Technical Service BULLETIN

OCCUPANT CLASSIFICATION SYSTEM INITIALIZATION (DTC B1150 & B1650)

'04 Camry, Highlander & Solara

ELECTRICAL
REVISÉD
EL002-04

**System
Operation
Overview****FIGURE 1****CAUTION USING A SEAT BELT EXTENSION:**

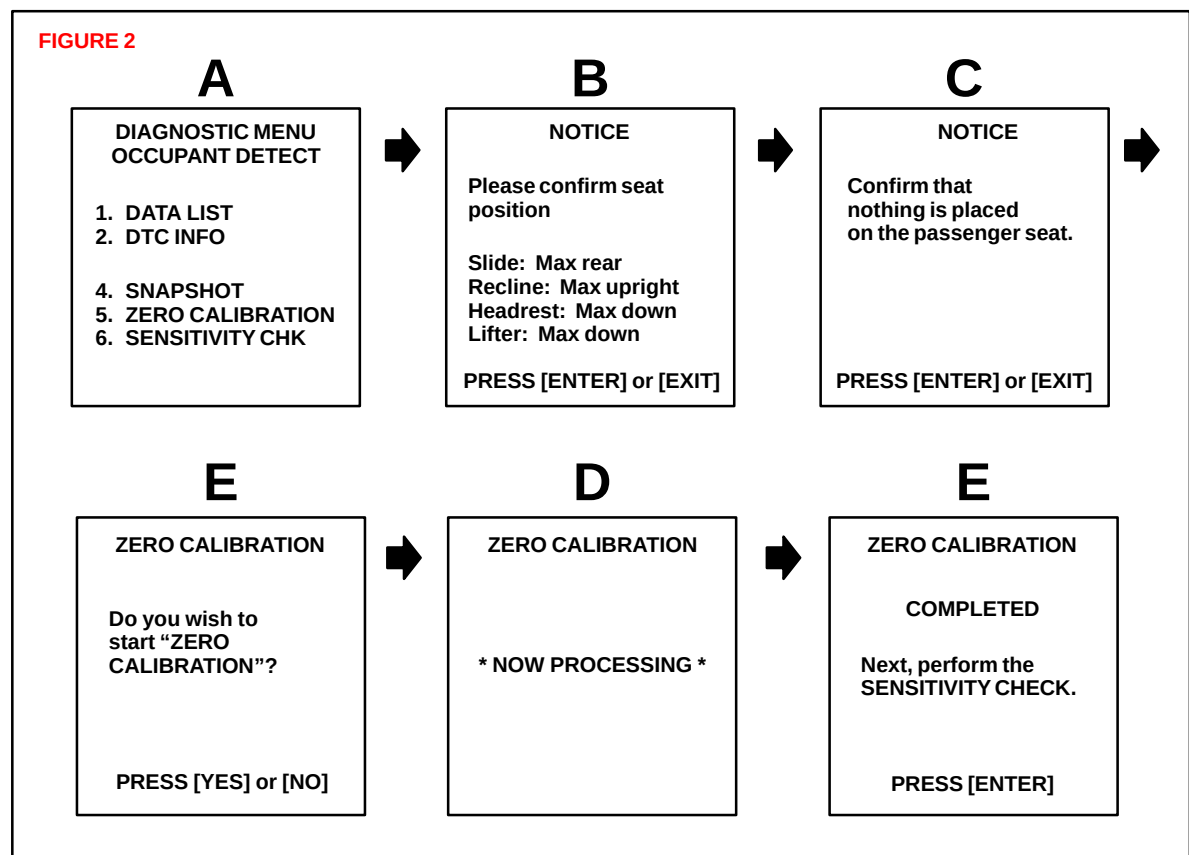
On vehicles equipped with SRS – Occupant Classification System (OCS), it is critical that the extender tab be buckled into the buckle **AFTER** the customer sits down in the seat.

Leaving the extender installed in the buckle before sitting down will cause the OCS to remain in the airbag "OFF" or disarmed state.

FIGURE 2

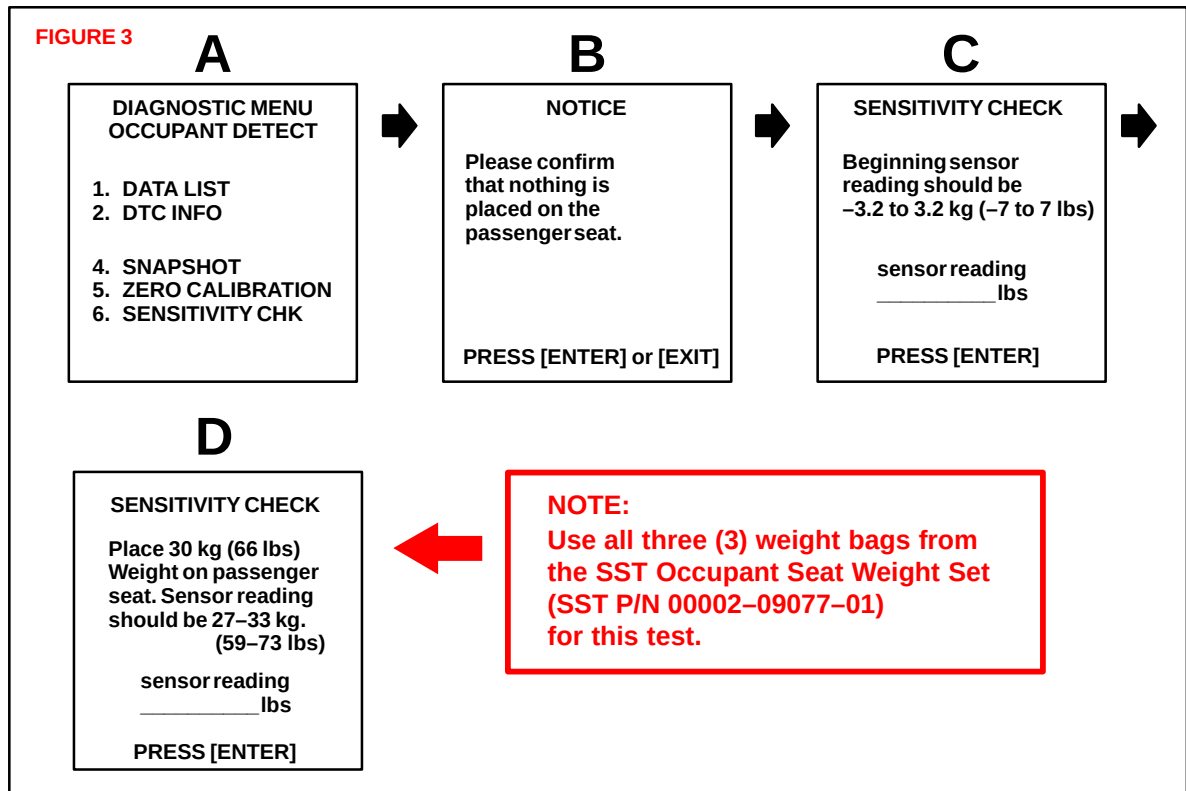
May 11, 2004: Introduction has been clarified, OCS SRS codes identified, new SST "Occupant Seat Weight Set" (P/N 00002-09077-01) added to Required Special Service Tools, "Note" added to Figure 3 on page 4.

Before performing Zero Point Calibration and Sensitivity Check verify the following:

- The seatback pocket is empty.
- Nothing is placed on the seat.
- Nothing is placed under the seat.
- Correct seat position per Diagnostic Tester instructions.

If ZERO CALIBRATION fails, check for DTCs and diagnose per repair manual instructions in the Technical Information System (TIS). Following any repairs, repeat Zero Point Calibration and Sensitivity Check.
